GUSSIE NELL DAVIS
RANGERETTE RESIDENCE
KILGORE COLLEGE

Addendum No. 1
to the Proposal Documents for
GUSSIE NELL DAVIS RANGERETTE RESIDENCE
KILGORE COLLEGE
Kilgore, Texas

Addendum No. 2
to the Proposal Documents for
GUSSIE NELL DAVIS RANGERETTE RESIDENCE
KILGORE COLLEGE
Kilgore, Texas

Addendum No. 3
to the Proposal Documents for
GUSSIE NELL DAVIS RANGERETTE RESIDENCE
KILGORE COLLEGE
Kilgore, Texas

MECHANICAL SITE PLAN

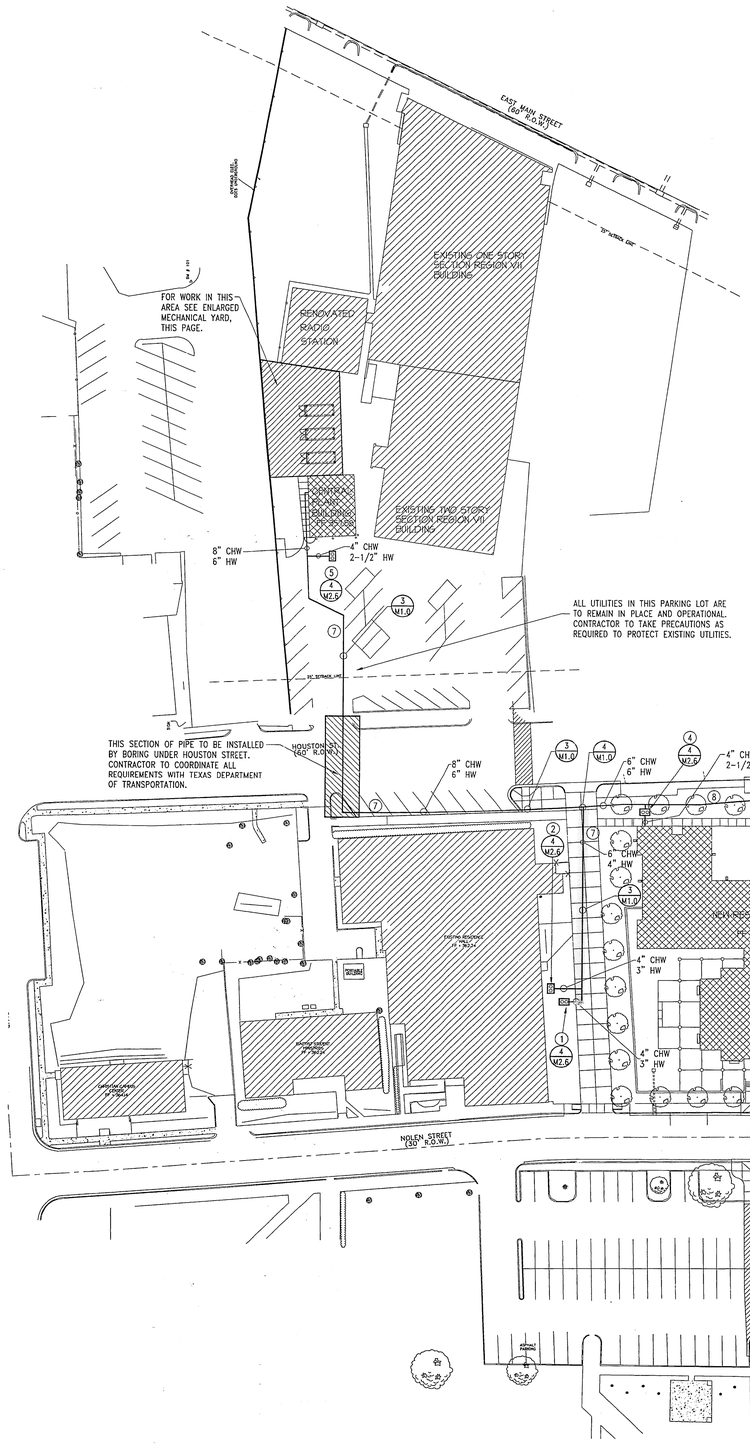
Sheet M 1.0
A. Refer to View #3 – Piping Tranch. Note that 8' minimum depth is only required for the portion of pipe to be installed beneath Houston Street. Minimum depth in all other locations will be 2'-0".

Sheet M 2.1

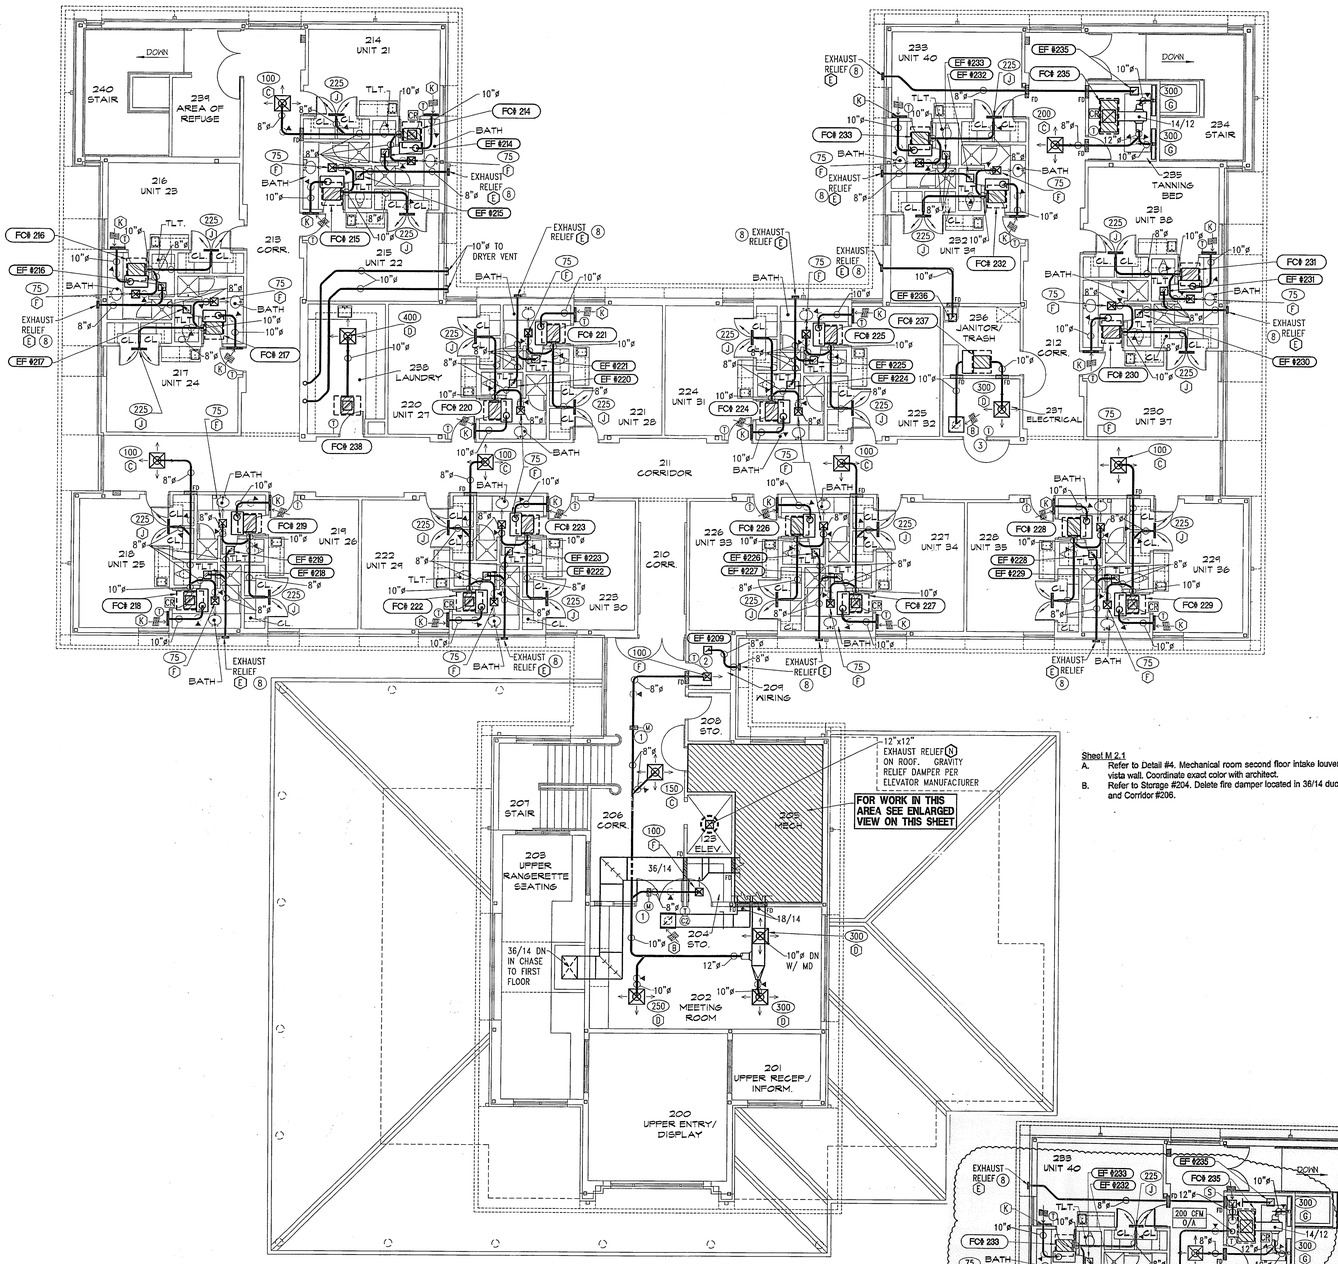
A. Refer to Detail #4. Mechanical room second floor intake louver to be painted to match vista wall. Coordinate exact color with architect.

Sheet M 2.2

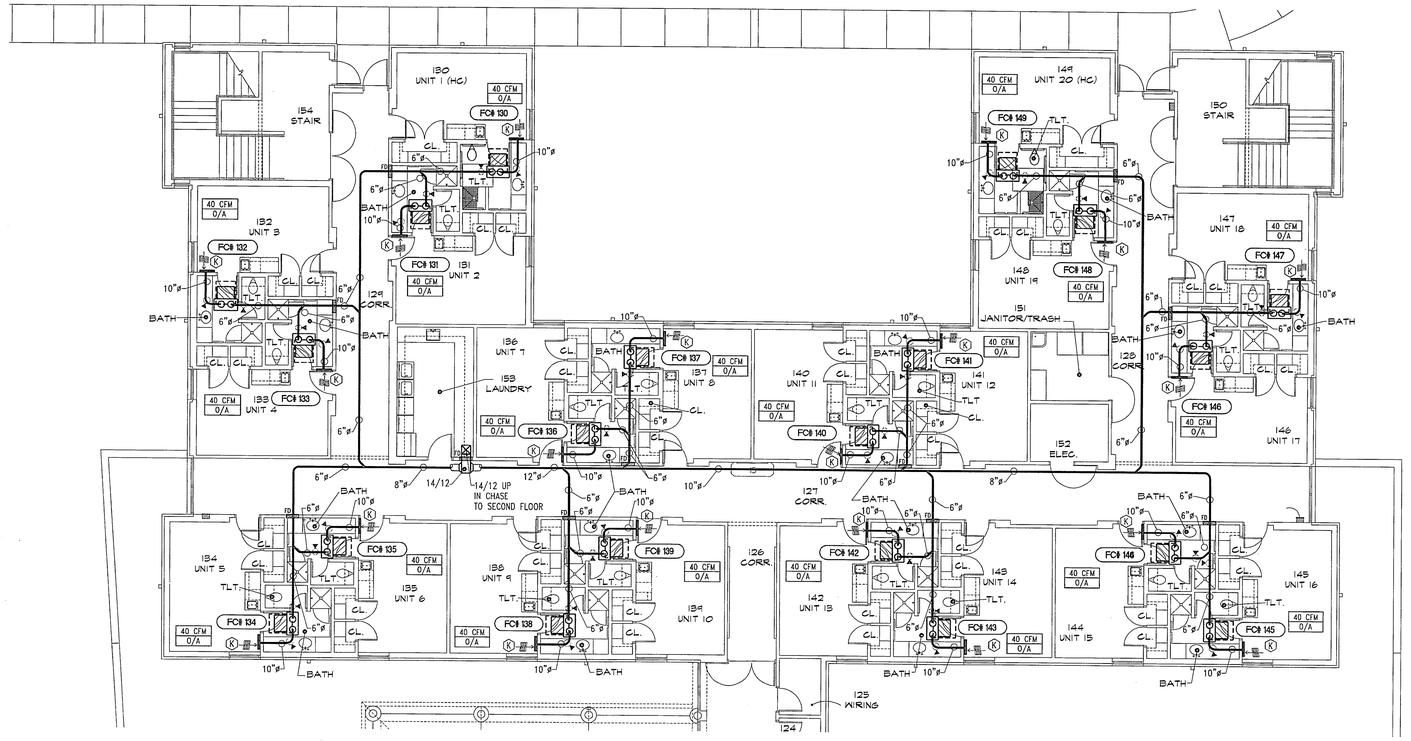
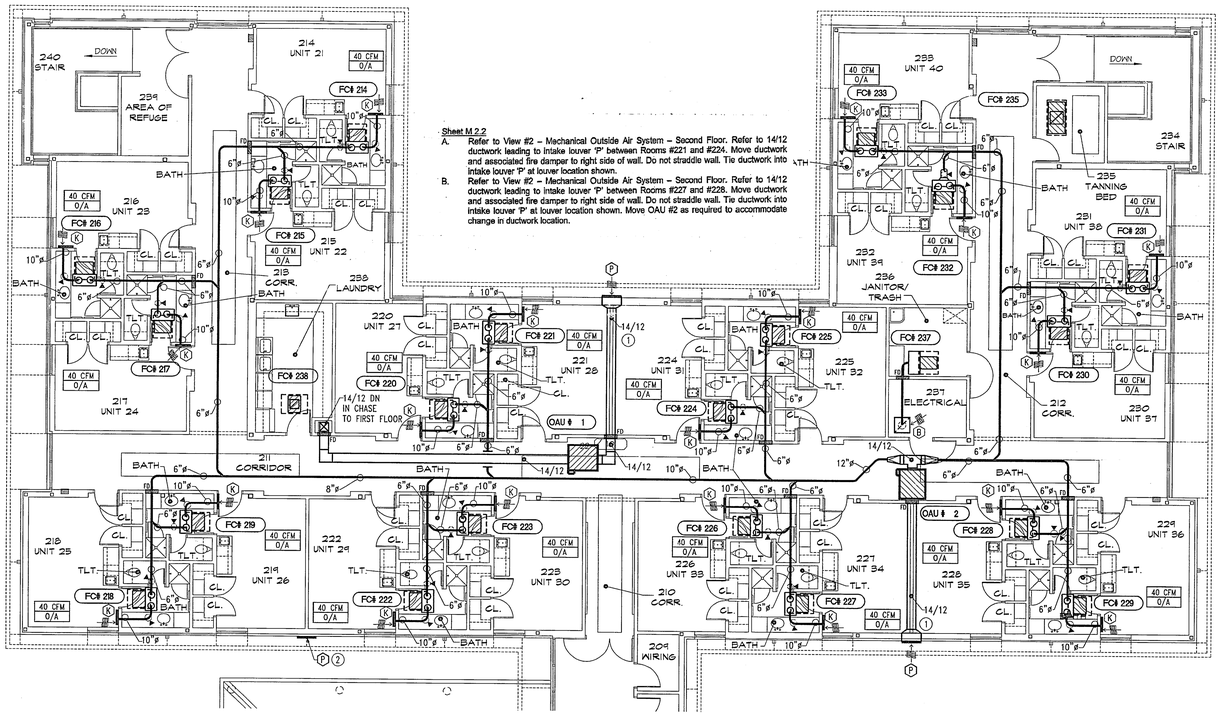
A. Refer to View #2 – Mechanical Outside Air System – Second Floor. Refer to 14/12 ductwork leading to intake louver 'P' between Rooms #221 and #224. Move ductwork and associated fire damper to right side of wall. Do not straddle wall. Tie ductwork into intake louver 'P' at louver location shown.

ELECTRICAL SITE PLAN

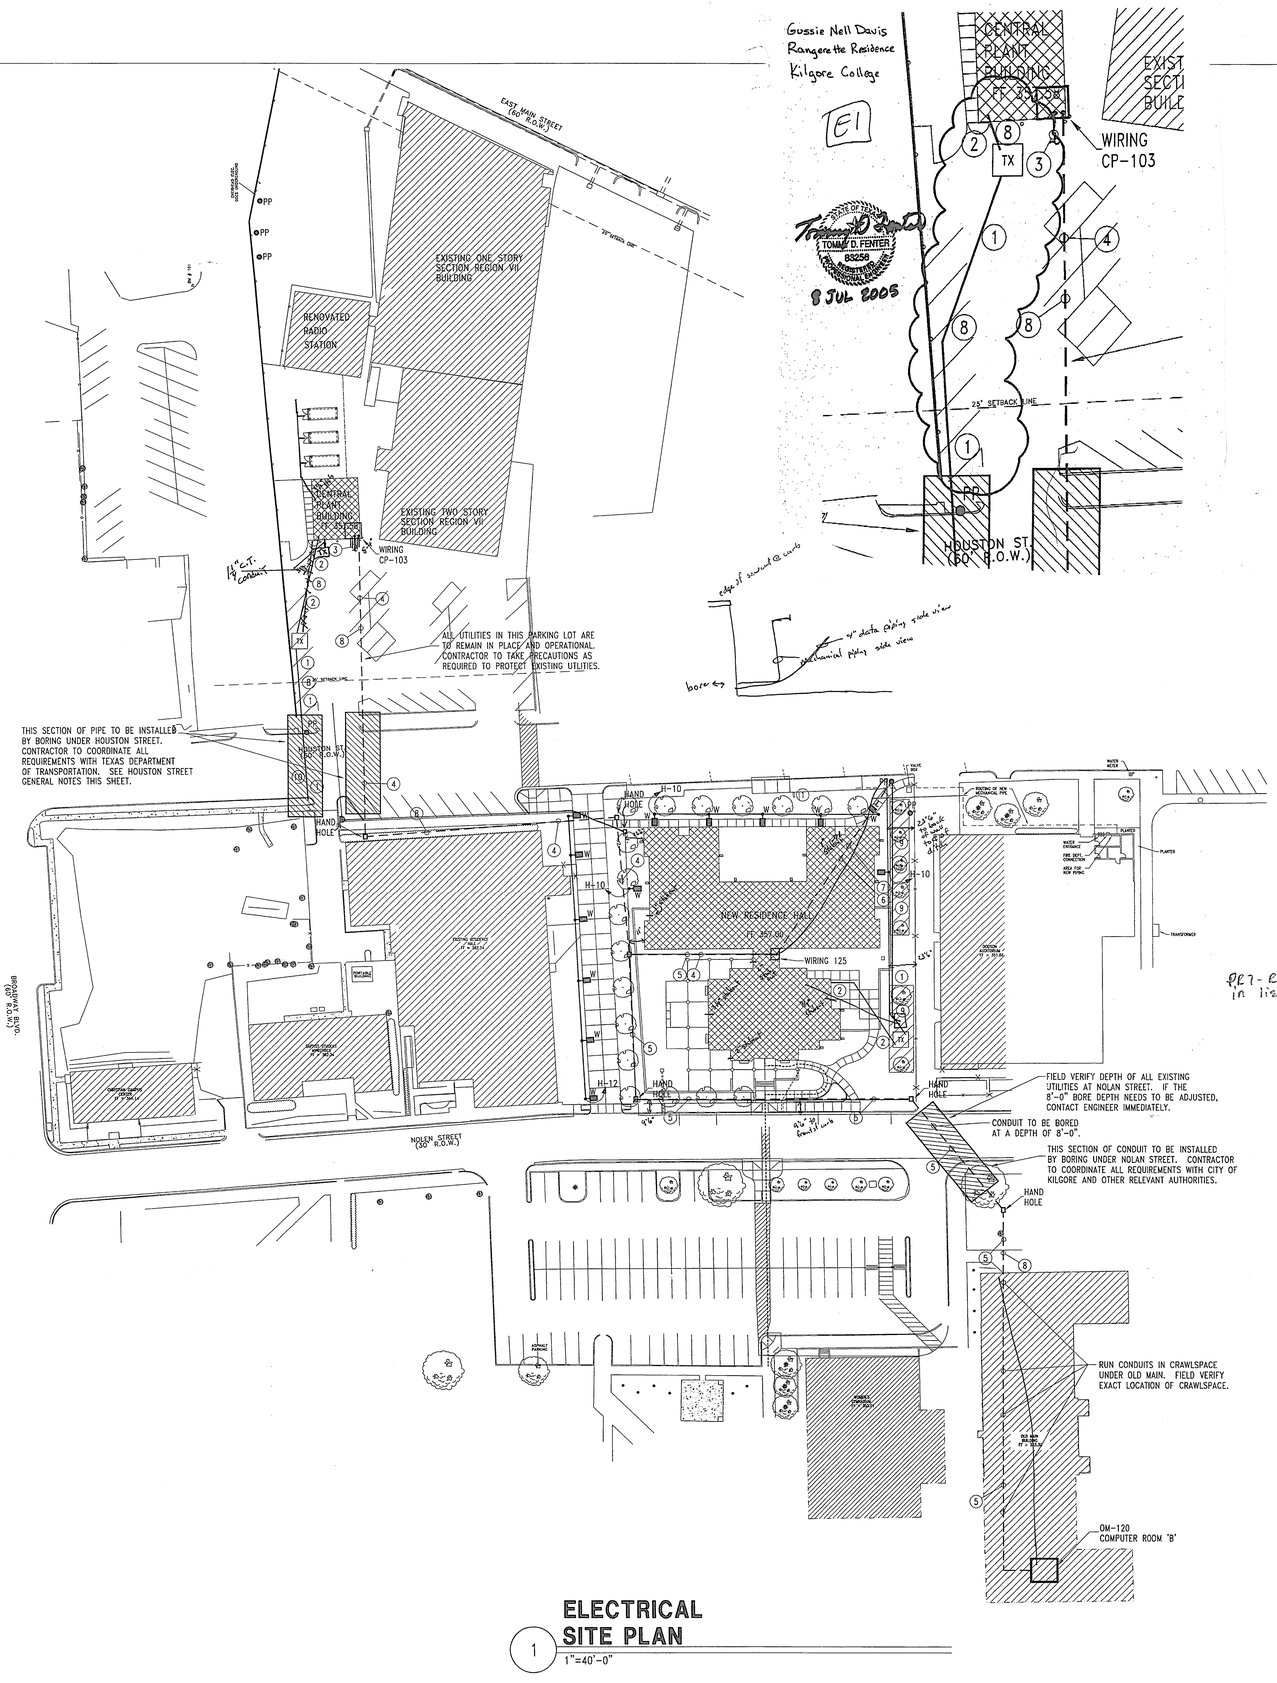
RP7-R1 Elec service over Houston st. in lieu of underg

Sheet E1.0
A. Refer to Site Plan.
1. For changes to site plan, see Attachment E1.

ELECTRICAL FLOOR PLAN- FIRST FLOOR

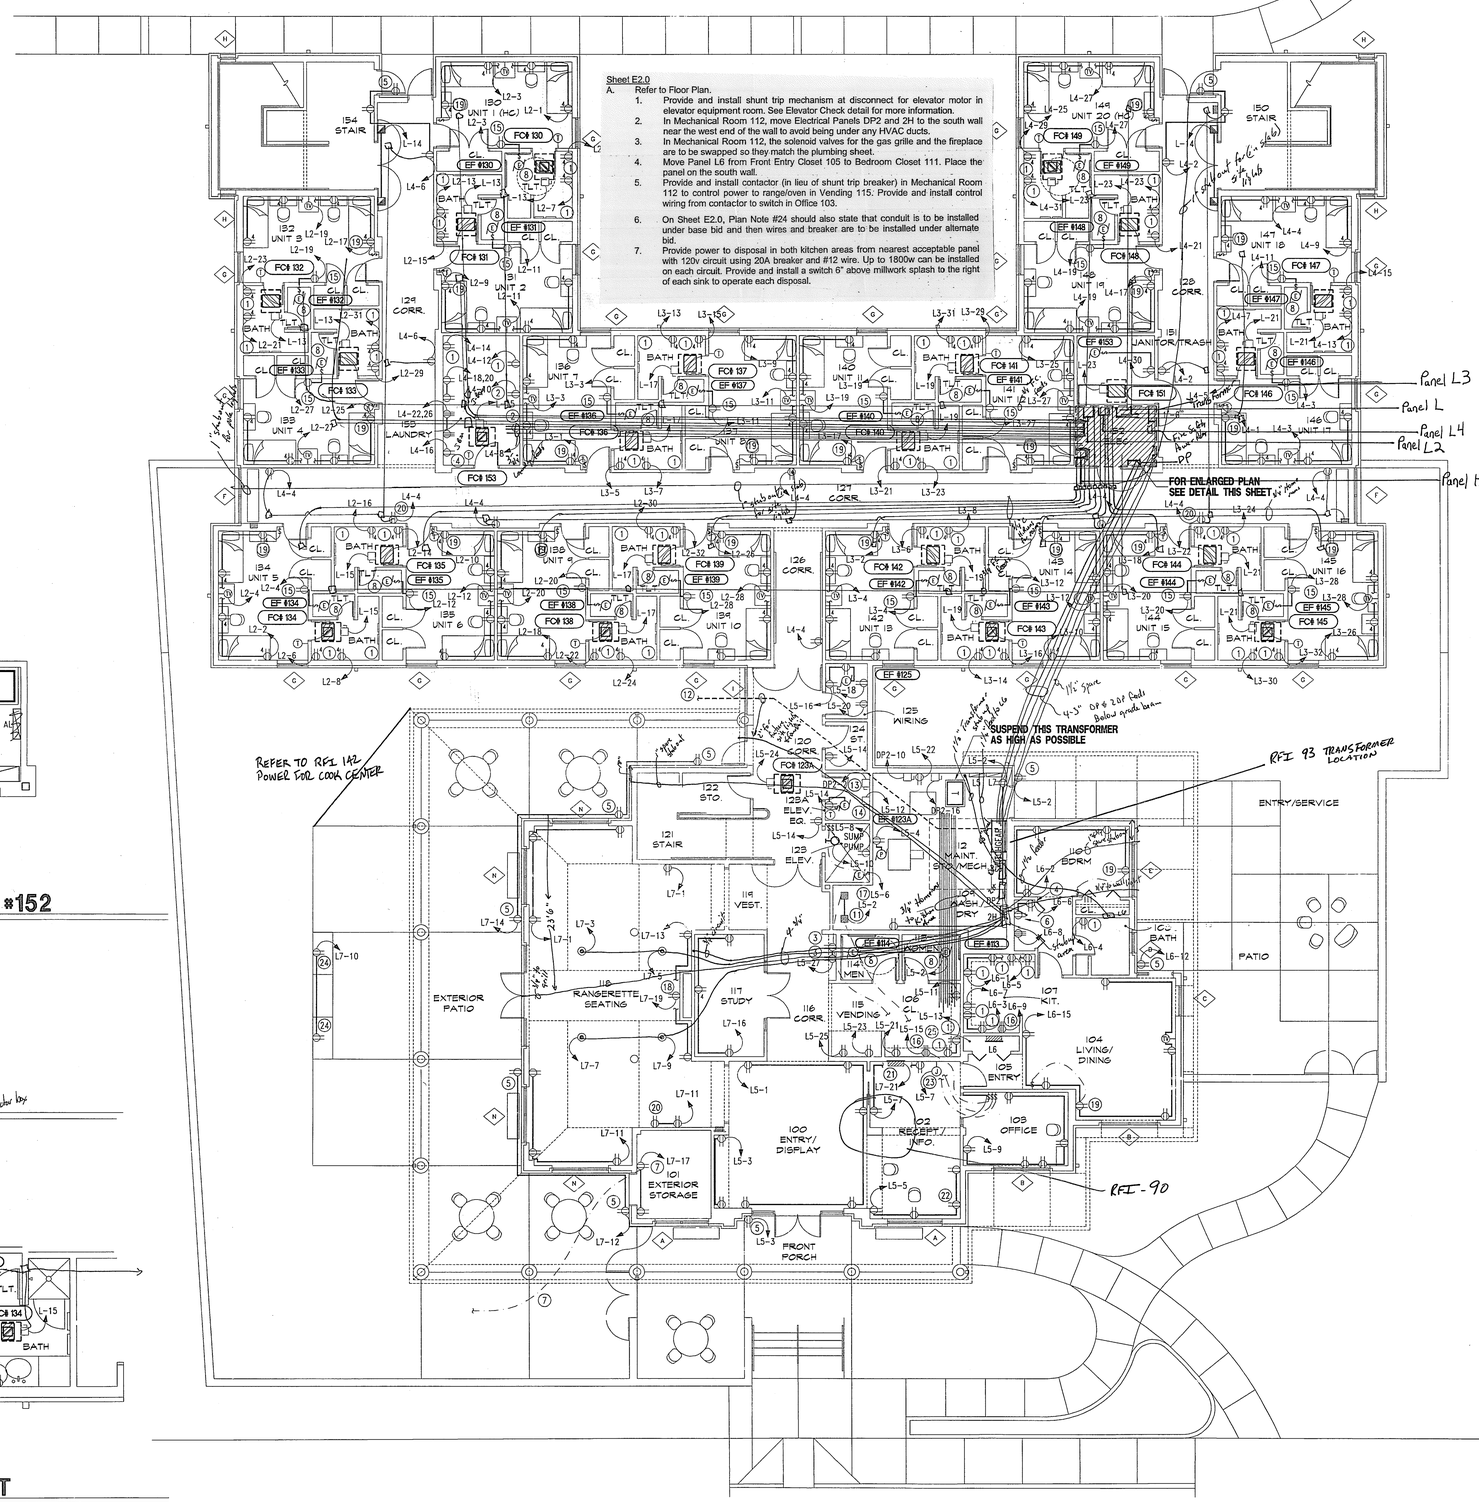
Sheet E2.0
A. Refer to Floor Plan.
1. All floor outlets are to be located per Architect.
